MANSFIELD INLAND WETLANDS AGENCY

- A. W1575- WILLARD J. STEARNS & SONS, INC., BROWNS & COVENTRY ROAD, 9 LOT SUBDIVISION
Memo from Wetlands Agent

From: Jennifer Kaufman, Inland Wetlands Agent

Subject: Street Address (File W1575)
Willard J. Stearns and Sons, Inc.
Description of Work: 9-lot subdivision-Mountain View Acres
Map Date: 12/15/2015, Revised Through 10/13/2015

**SITE DEVELOPMENT PLAN
 MOUNTAIN VIEW ACRES
 #522 BROWNS ROAD
 & COVENTRY ROAD
 MANSFIELD, CONNECTICUT**

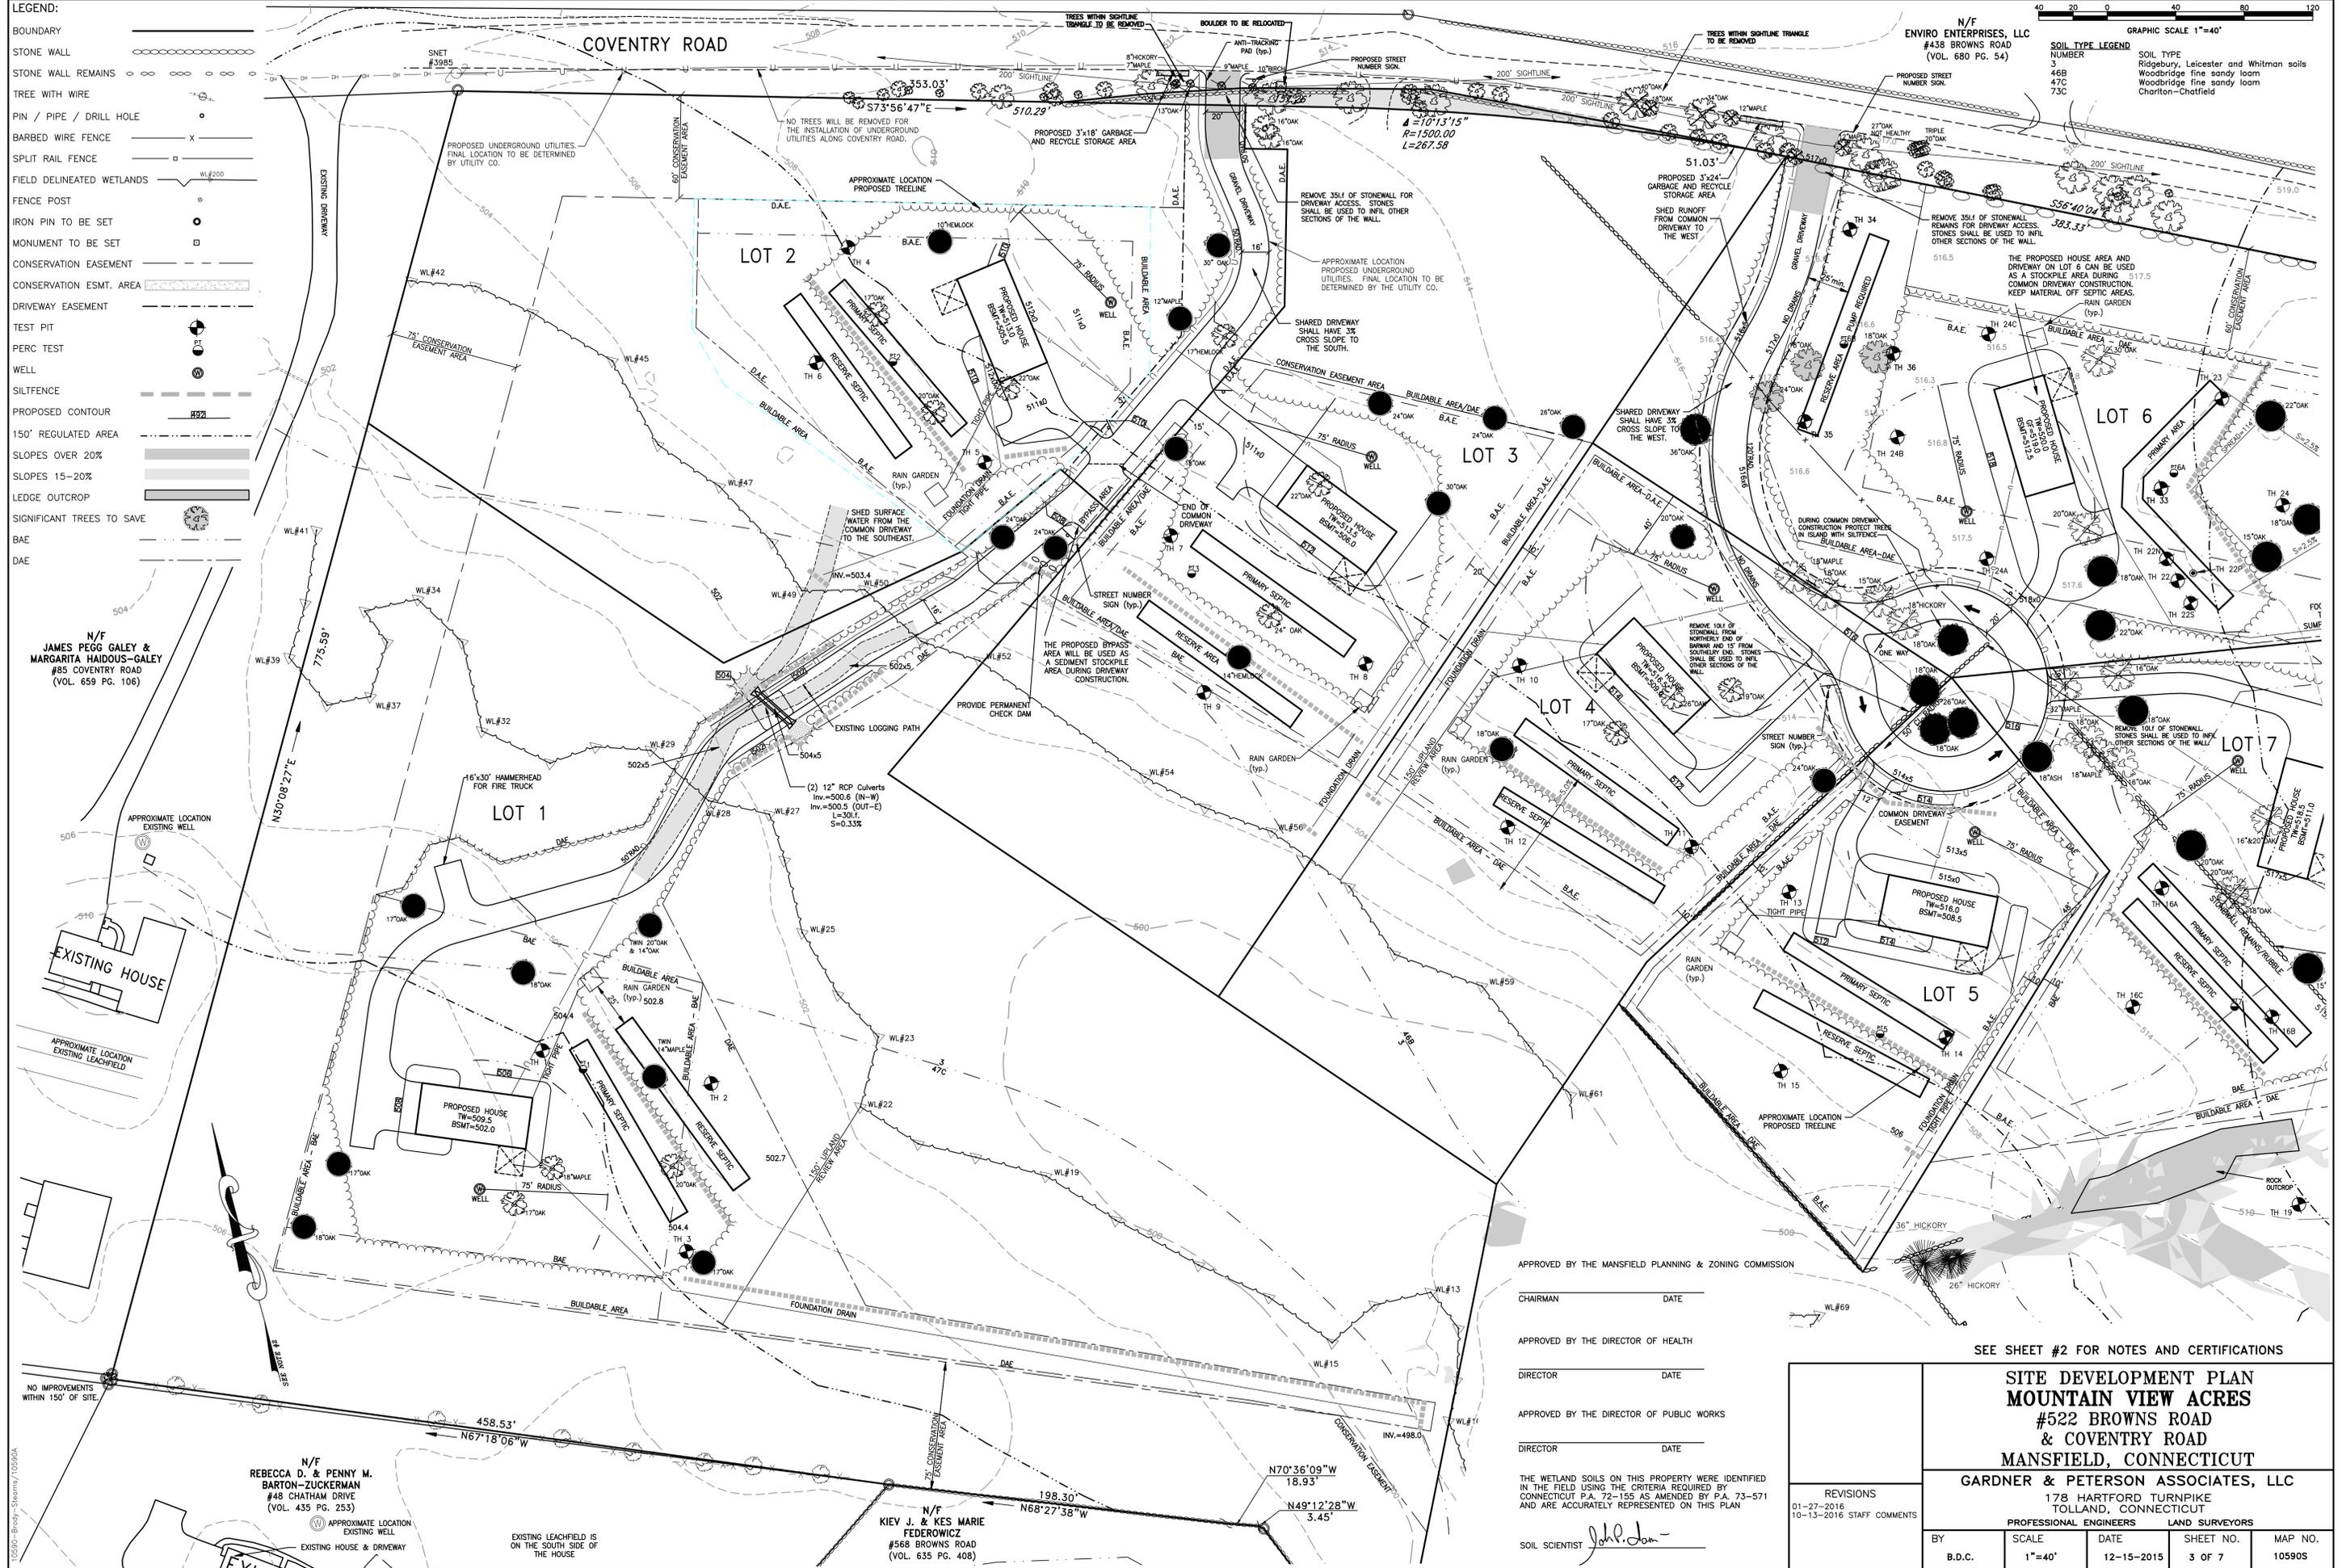
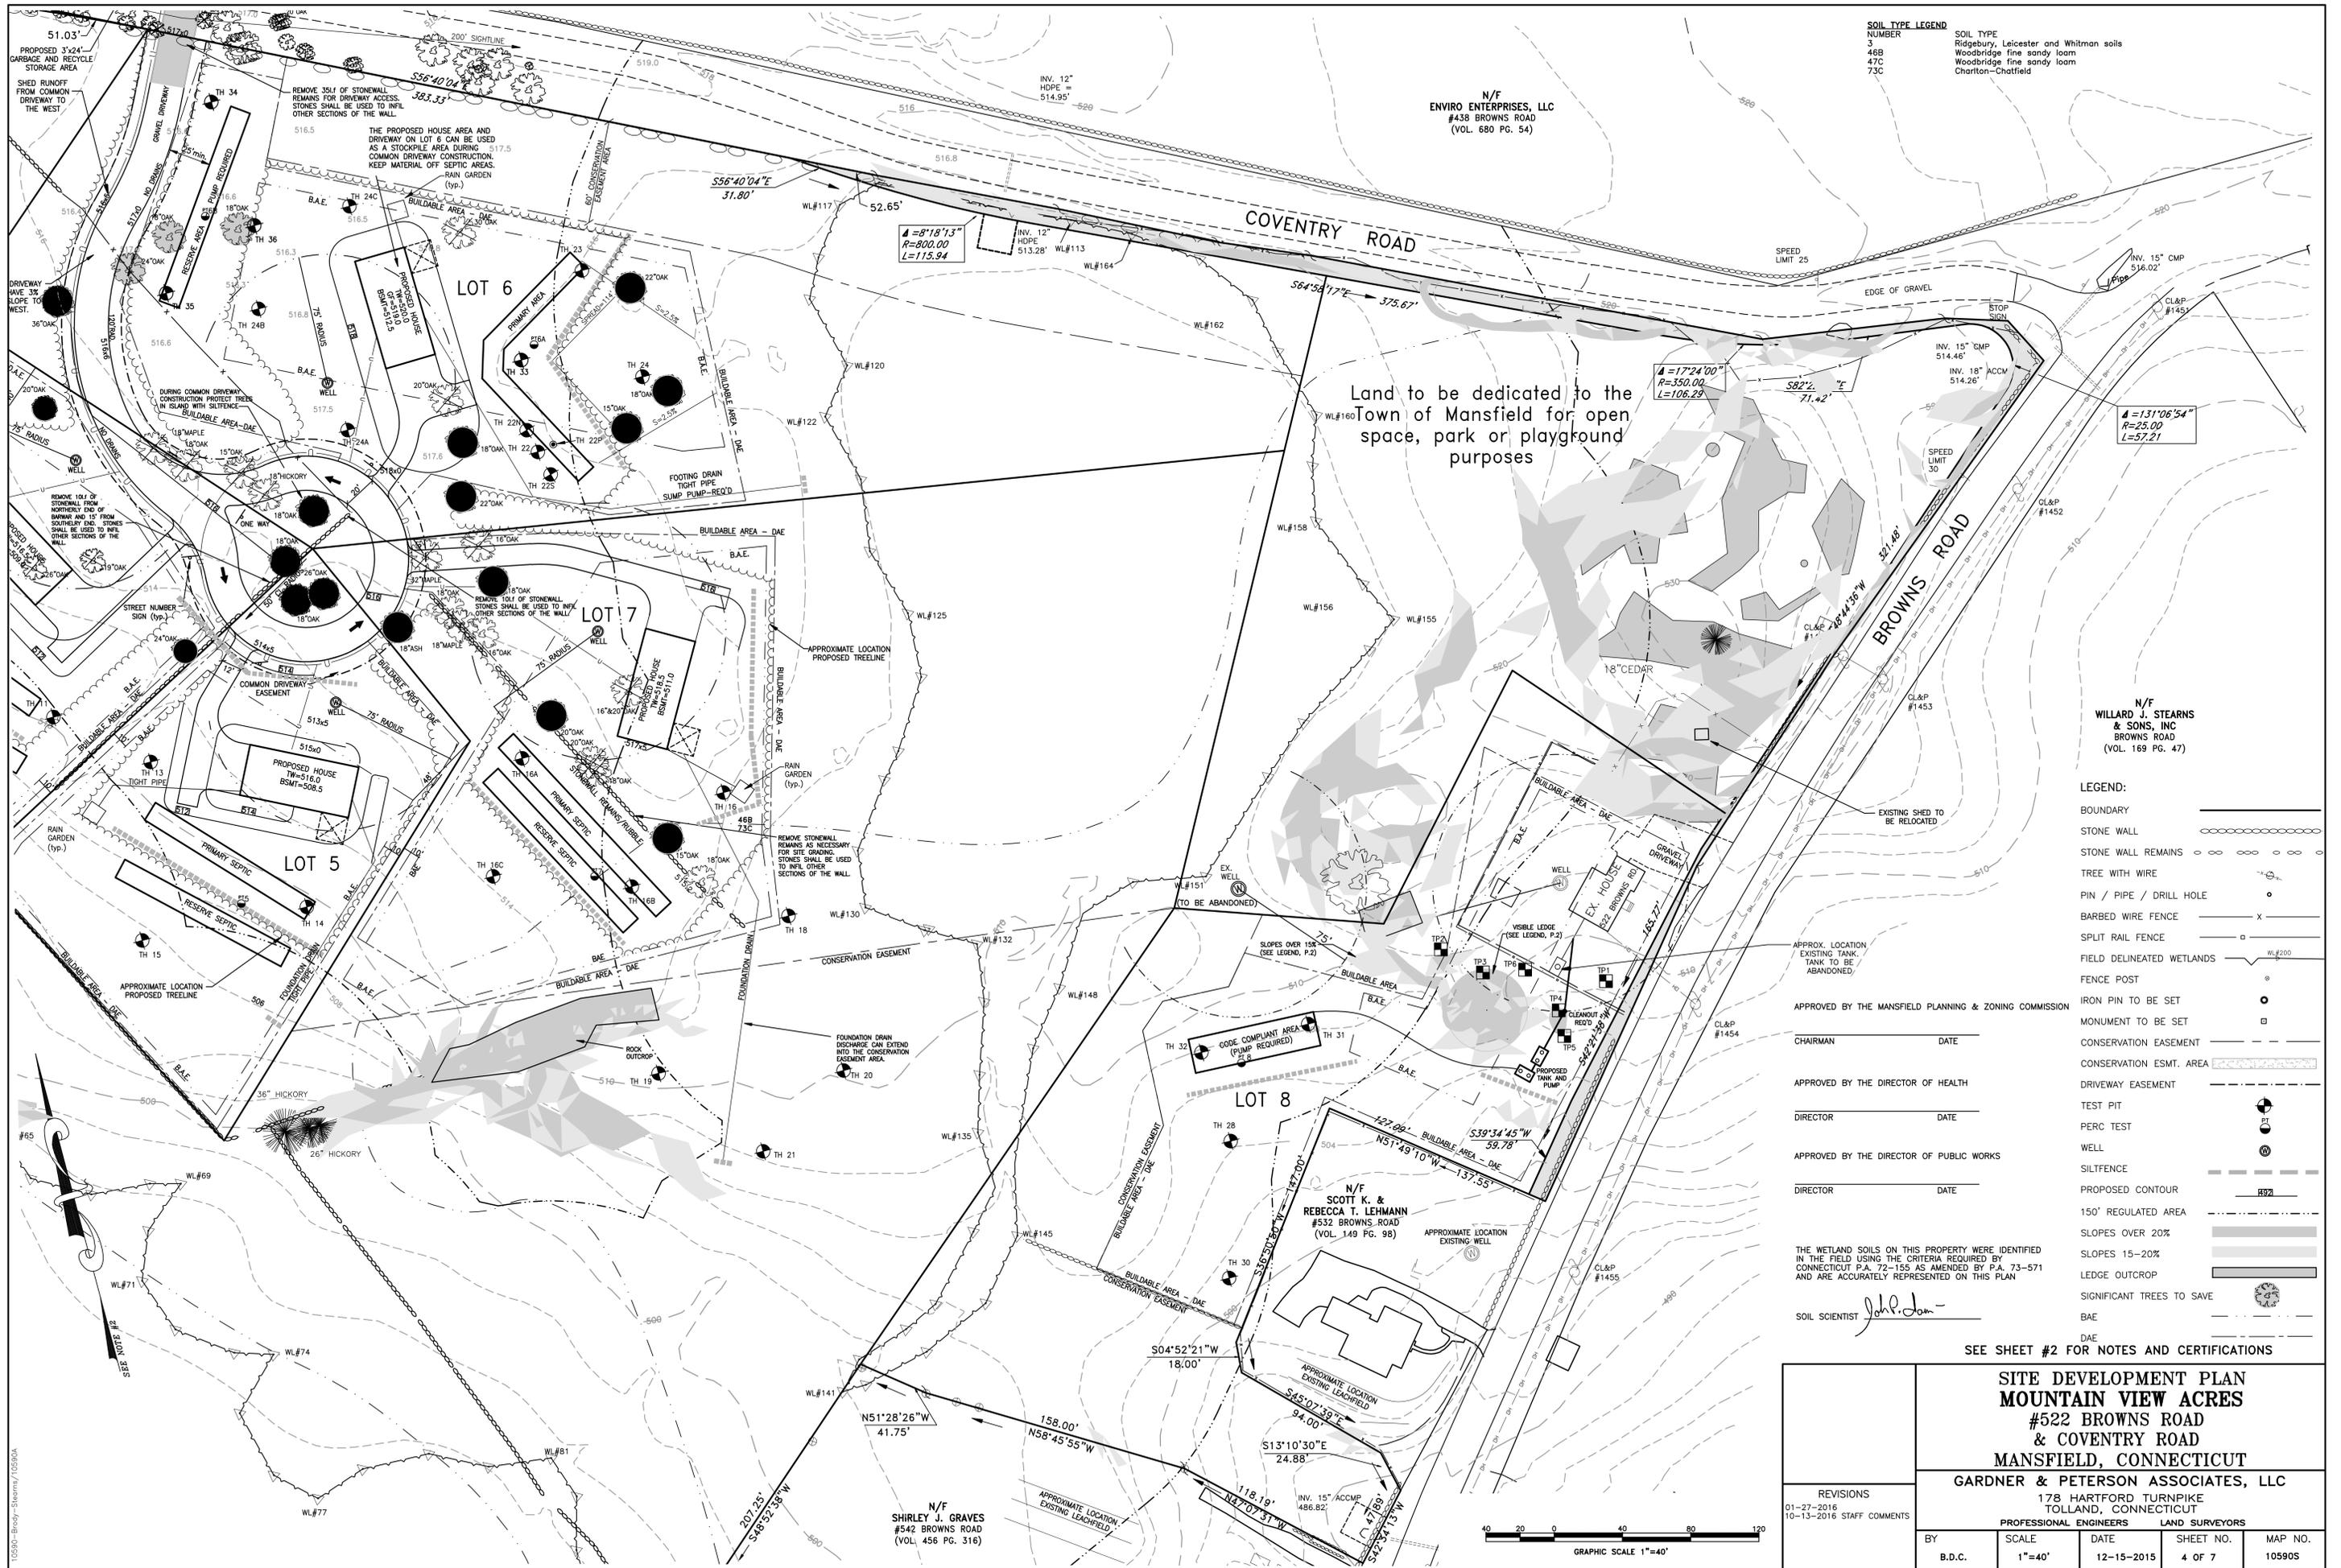
It is here that the applicants proposed a 4800 square foot permanent direct wetland impact to create a drive way to access lot 1. Construction in the wetlands includes 14 feet wide and approximately 150 feet long driveway. An additional 300 feet of driveway will be constructed in the upland review area. The driveway will be constructed of 6 inches of bank run gravel topped with 2 inches of processed gravel. Two 12 inch reinforced concrete pipes (RCP) will be installed at the area identified as the centralized flow path. I have consulted with the Assistant Town Engineer and, in his professional opinion, the RCPs are adequately sized for the predicted flow. When the RCPs are installed, instead of silt fence, I recommend using a stone berm check dam downstream to capture sediments resulting from installation of the culvert.

The proposed driveway is located in in the narrowest portion of the wetland and in an area previously disturbed (approximately 5 years ago) as part of a logging operation. Since the logging operation the area has started to revegetate. According to Highland Soils, LLC. Retrorse sedge (an obligate wetland plant according to the US Army Corps of Engineers National Wetland Plant List) is well established and areas of shrub growth are beginning to colonize the disturbed area. At the public hearing the IWA should obtain clarification from the applicant's soil scientist as to whether, in his professional opinion the driveway will fragment the wetland and significantly impact the functions and values of the wetland.

There has been a vernal pool identified on site. No activity is proposed within the vernal pool or within 100 feet of the vernal pool and the Critical Terrestrial Habitat (750 feet from the vernal pool) will have less than 25% development which is within the recommendations of the Best Development Practices developed by Calhoun and Klemens in 2002. The applicants are proposing a conservation easement in the area of the vernal pool. I recommend reducing the Building Area and Development Area Envelopes where possible in areas that are within 750 feet of the vernal pool.
